**MOORE PUBLIC SCHOOLS -
WESTMOORE HIGH SCHOOL
ENTRY UPGRADES**

ADDENDUM NO. 1

May 20, 2026

Project Information

1 TECHNOLOGY FLOOR PLAN
SCALE: 3/32" = 1'-0"

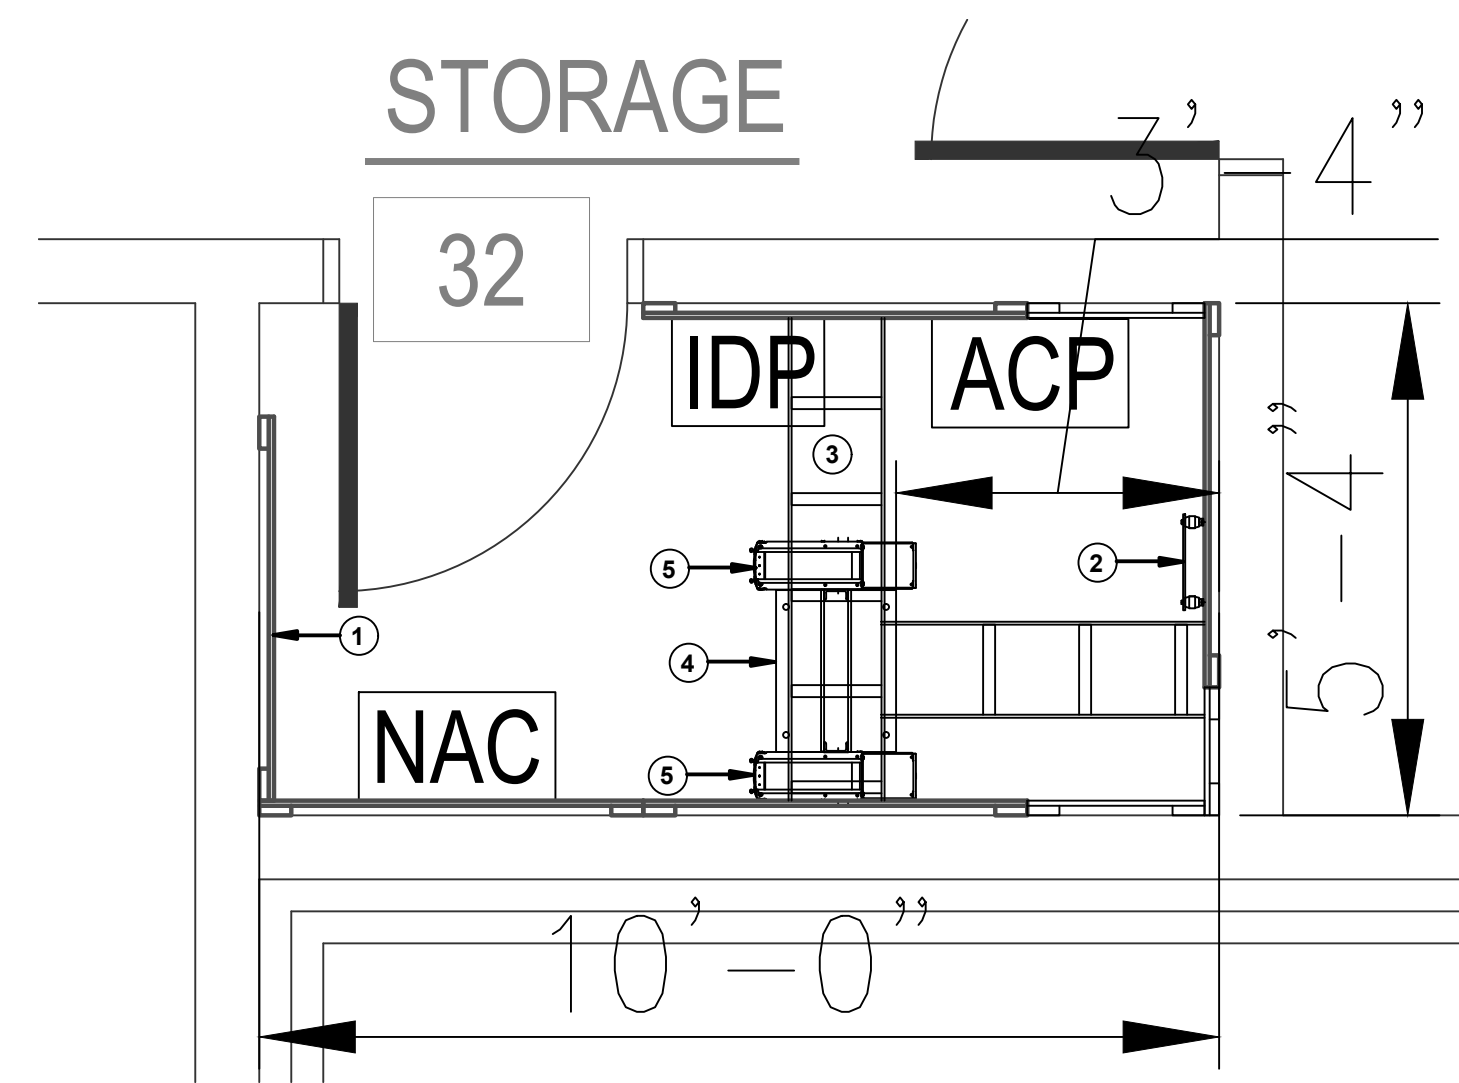
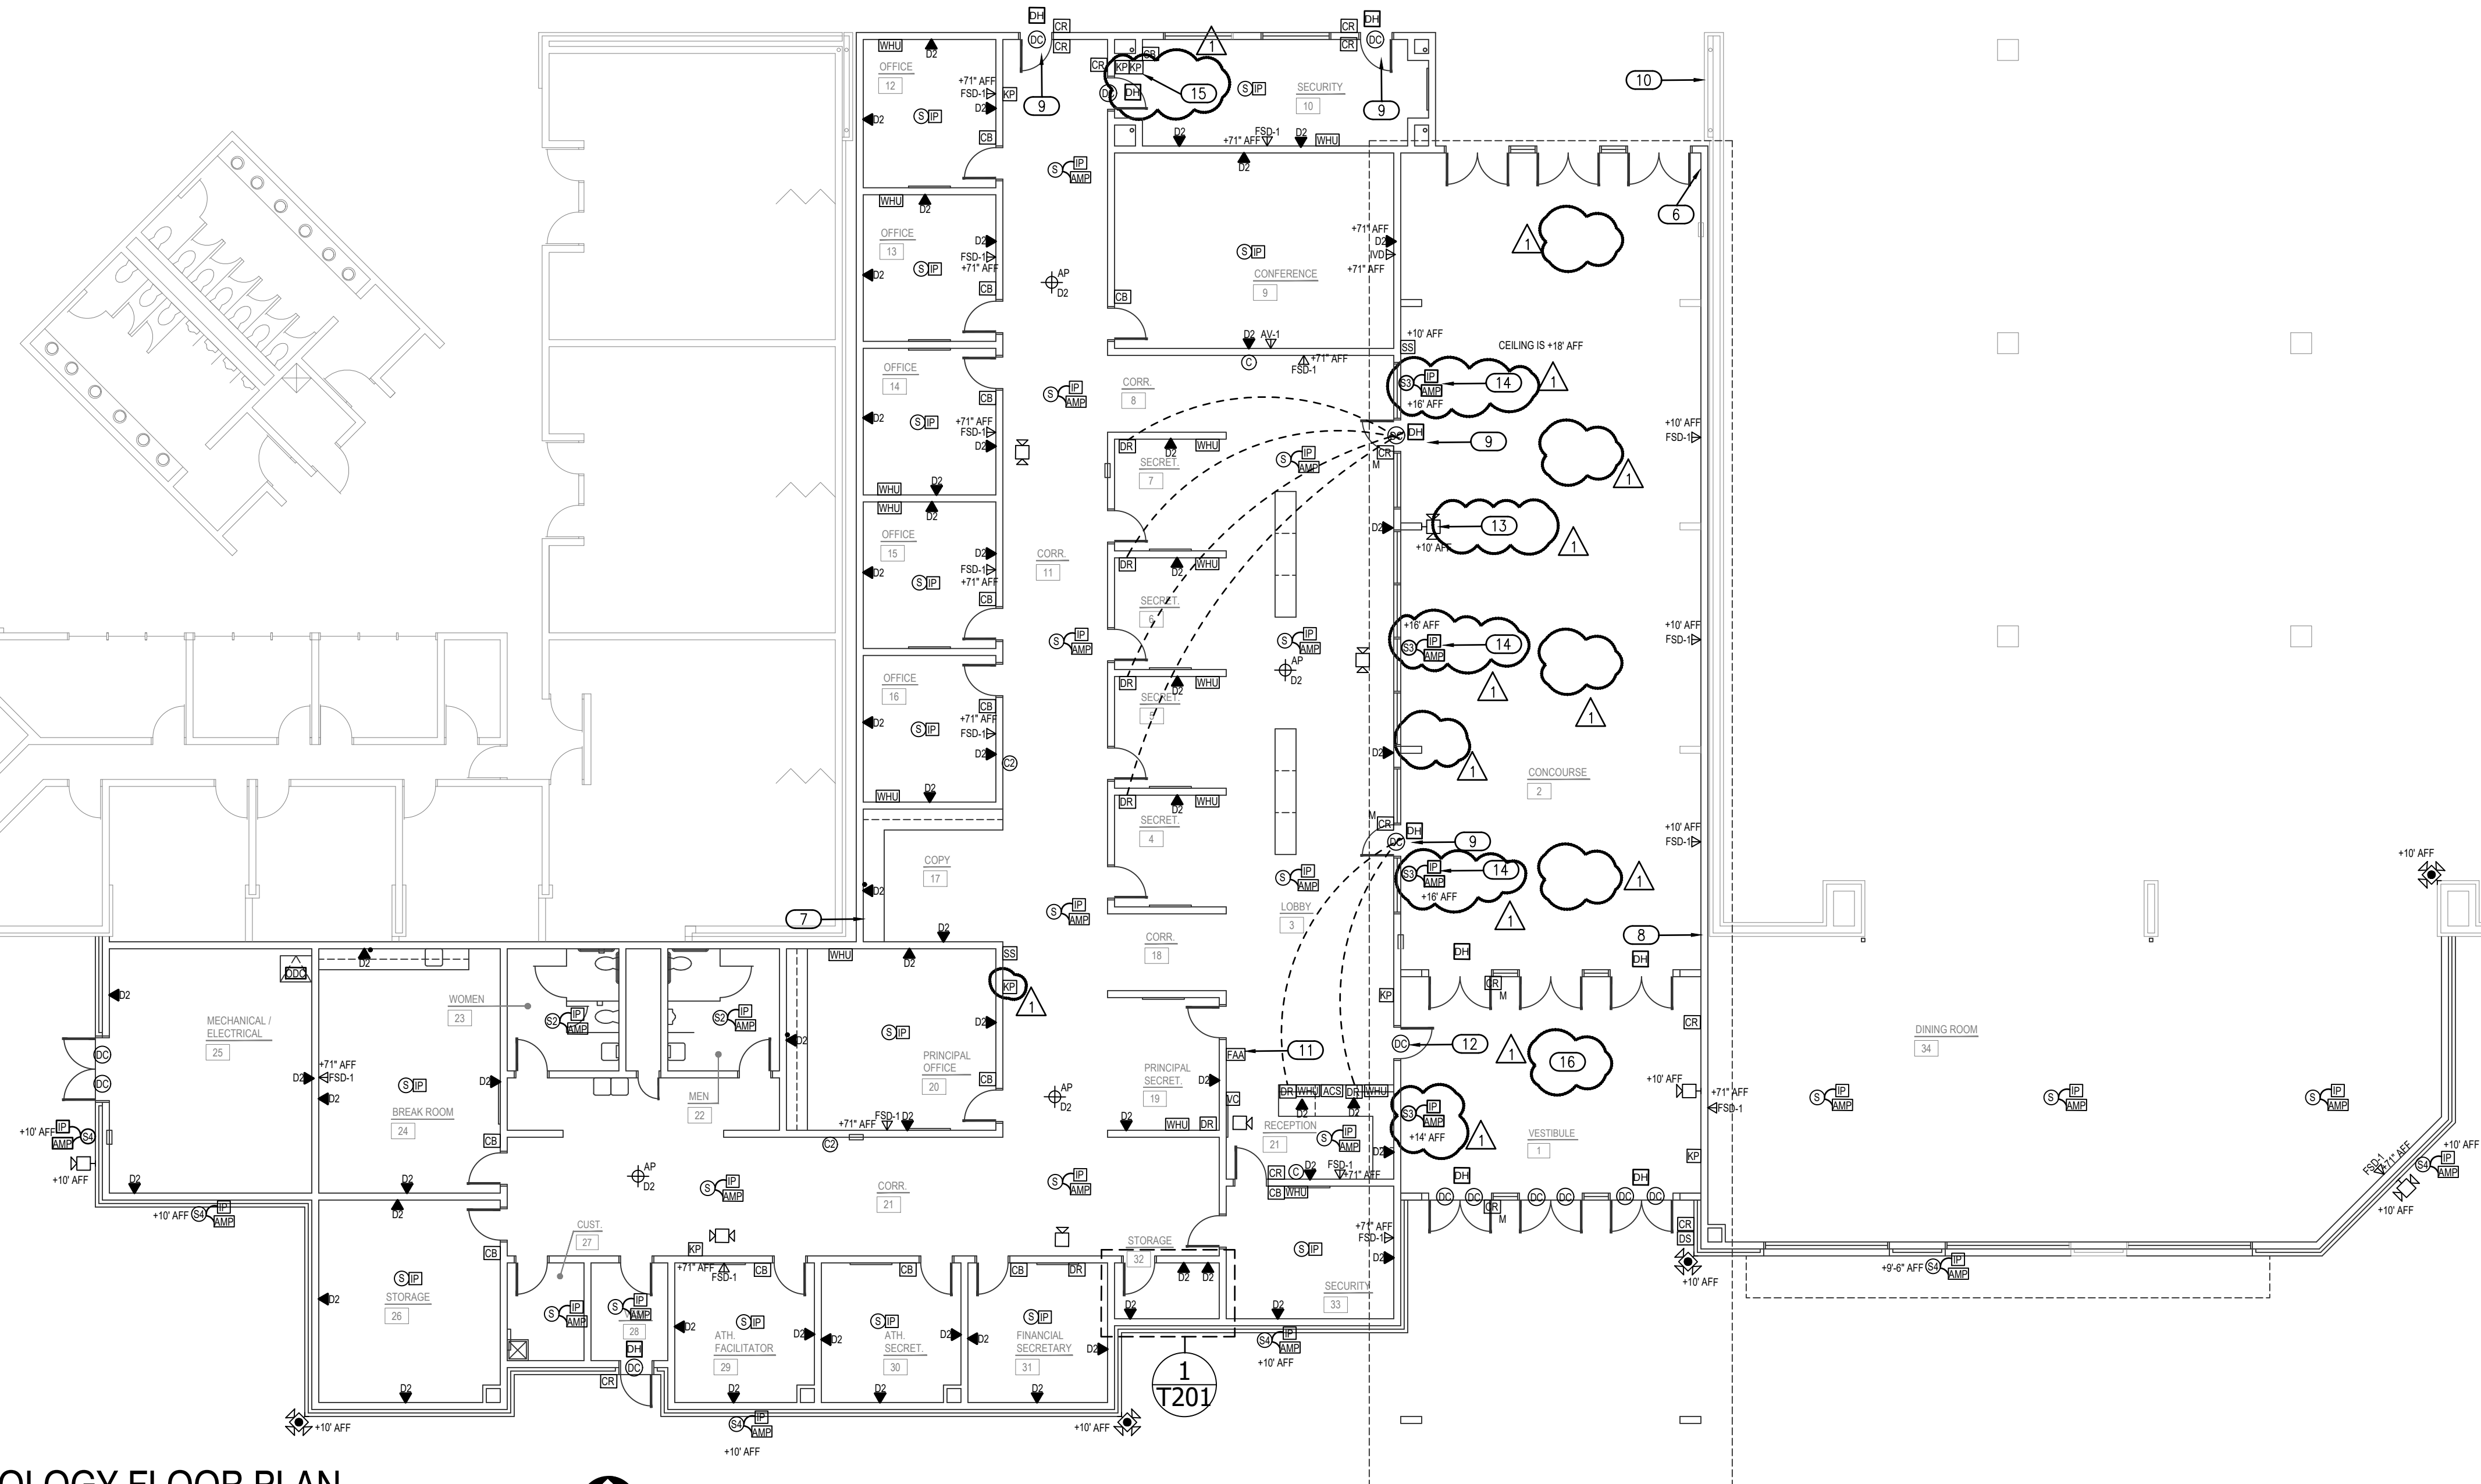
- ▲ F101 FIRE PROTECTION PLAN
 - Refer to clouds and deltas for changes on plans.
- ▲ E000 ELECTRICAL TITLE SHEET
 - Refer to clouds and deltas for changes on plans.
- ▲ E101 ELECTRICAL LIGHTING PLAN
 - Refer to clouds and deltas for changes on plans.
- ▲ E201 ELECTRICAL POWER PLAN
 - Refer to clouds and deltas for changes on plans.
- ▲ E601 ELECTRICAL SCHEDULES
 - Refer to clouds and deltas for changes on plans.
- ▲ T000 TECHNOLOGY NOTES AND LEGENDS
 - Refer to clouds and deltas for changes on plans.
- ▲ T201 TECHNOLOGY FLOOR PLAN
 - Refer to clouds and deltas for changes on plans.
- ▲ M101 MECHANICAL FLOOR PLAN
 - Refer to clouds and deltas for changes on plans.
- ▲ M501 MECHANICAL DETAILS
 - Refer to clouds and deltas for changes on plans.
